November 7, 2018

Product Change Notice - New plastic catch on 07 series baggage doors

Fig.2

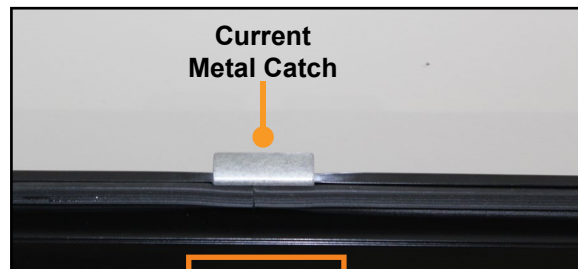
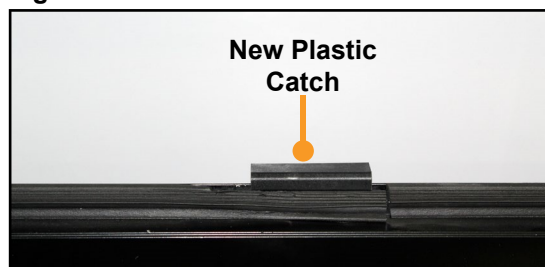
Currently, the catch is metal (Fig. 2), which requires two screws for installation from underneath the door frame (Fig. 2A). The new catch is plastic (Fig. 3) and uses snap-on installation making replacement of the catch easier. The new catch is snapped on over a glue dot for added strength

Along with ease of replacement, the function of the door will be improved. With the new plastic catch, the door will latch itself if the user lets the door fall shut. Currently, the door will only latch if the user pushes it closed.

The part number for the catch will change from 645469 metal to 767855 plastic. The part number for the glue dot is 767856. However, the part number for the door will not change, so there will be no change in order process for the customer. The change will take place on or around Jan. 1, 2019.
